ADDENDUM # 2

**CONSTRUCTION NEW LGBTQ CENTER, INCLUDE DEMOLITION RUGGELS HOUSE –
URI**

Date: 1 October 2013
Project: 1203 URI- LGBTQ Center
Description: Addendum #2

Project Name:
URI-LGBTQ Center
Kingstown, RI

PLAN DETAILS
SKA-002

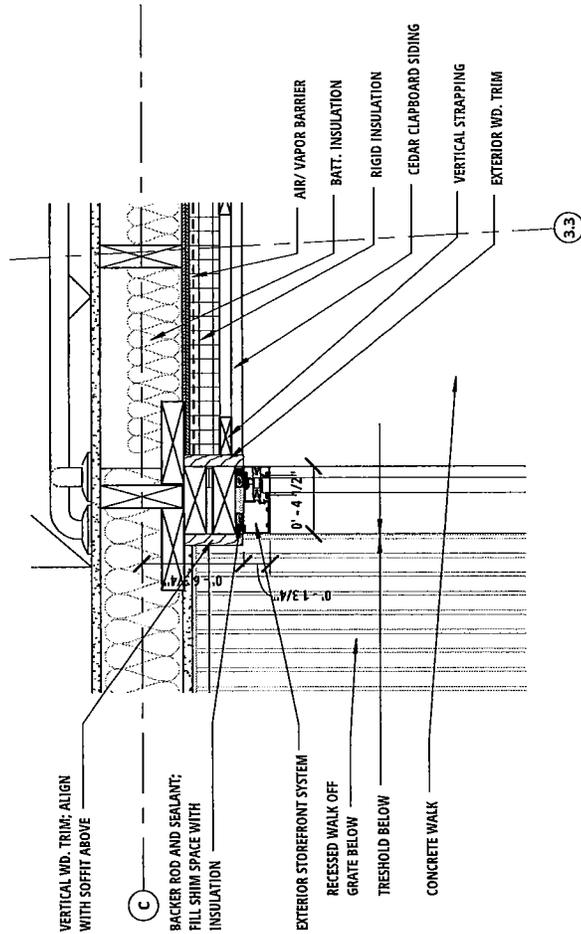
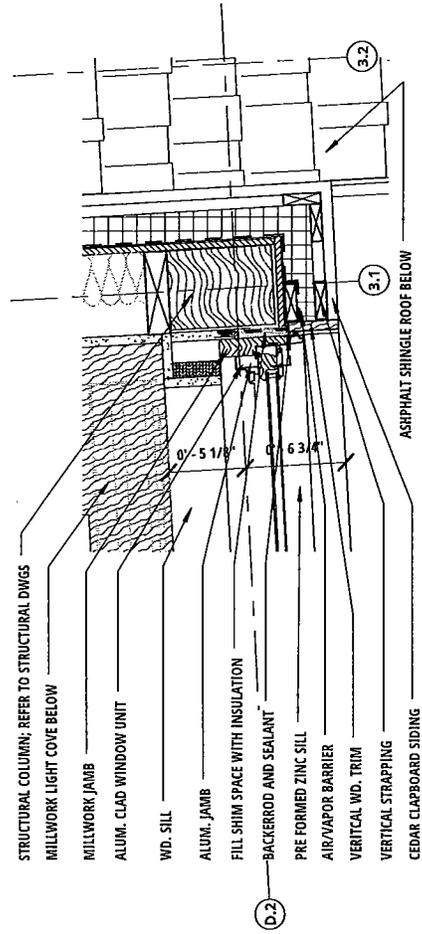
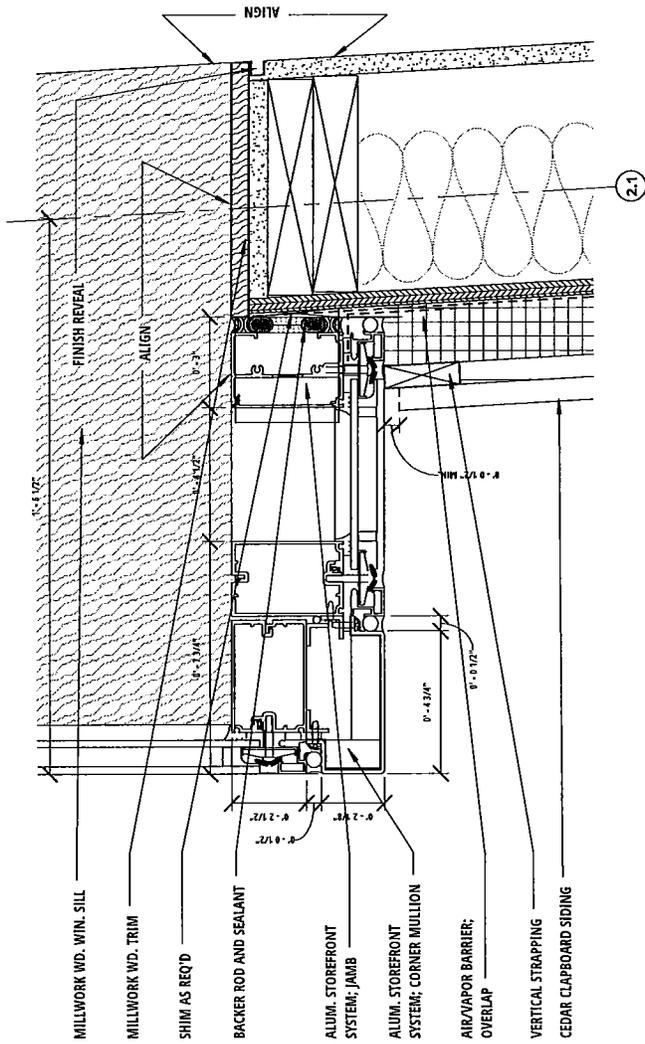
ADDENDUM #2
 REVISES DETAILS A2.2/A10.00 & B2/A10.01
 10/01/2013

A1
SKA-001

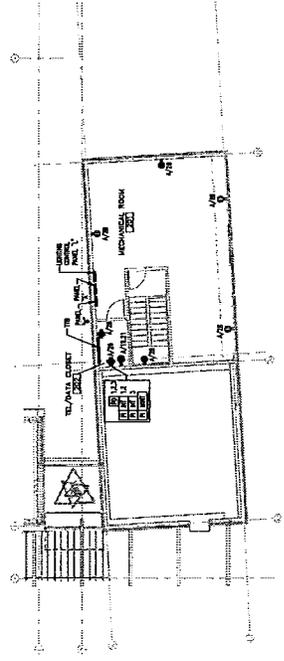
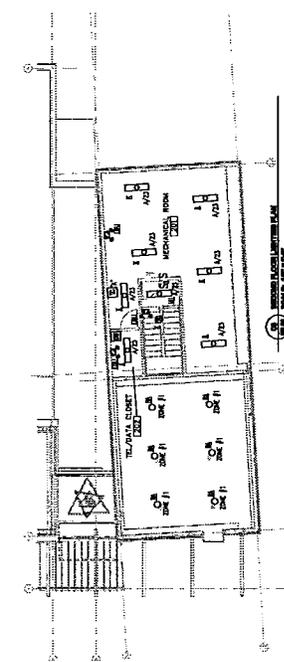
Item #	Drawing#	Drawing Description
		<u>Action</u>
D01	C0.02	Drainage, Utility, and Erosion and Sedimentation Control Plan (REISSUED IN ENTIRETY)
D02	A9.00	Door Schedule (SEE REVISION CLOUDS)
D03	SKA-001	Detail at Multipurpose- Window Box ADD Detail B2 to sheet A9.20
D04	SKA-002	Detail at Multipurpose- Bay Window Above Revises Detail A2.2/A10.00 & Enlarged Plan at East Vestibule- Clapboard Revises Detail B2/A10.01
D05	E1.00	Electrical Site Plan (SEE REVISION CLOUDS)
D06	E2.00	Electrical Lighting Power & Systems Plans (SEE
